Product/Process Change Notice (PCN)

PCN #: ConMPC3_150106_design change
Product Affected: 6620xx21122 & 6620xx235922 &
6623xx235922 & 6620xx231822 & 6623xx231822 &
6620xx21022 & 6620xx236022 & 6621xx236022 &
6620xx230822 & 6621xx230822 & 6620xx231722 &
6621xx231722

PCN Date: January 20th, 2015

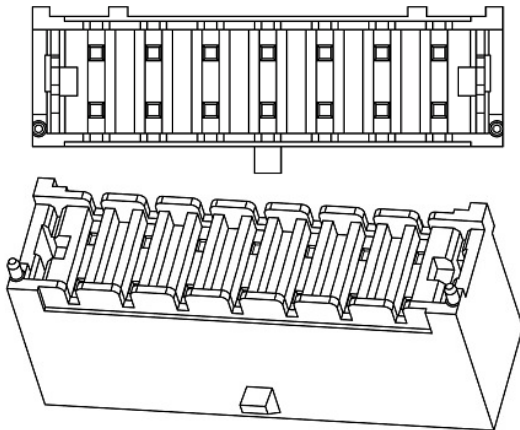
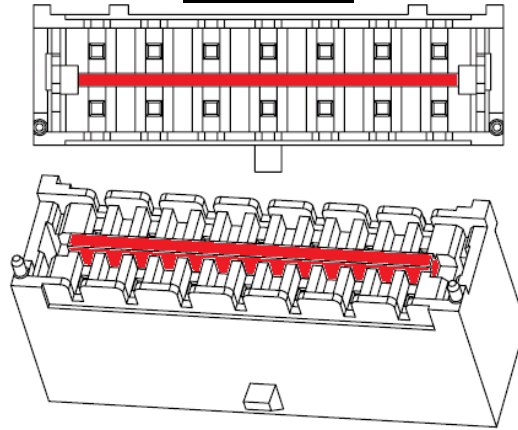
Addition of a rib between pin rows on plastic bodies of MPC3 connectors for better electrical insulation.

The plastic rib increases the creepage distance between the rows of pins and thus insures better electrical insulation. There is no impact on soldering. The air can still flow under the rib on vertical versions of connectors.
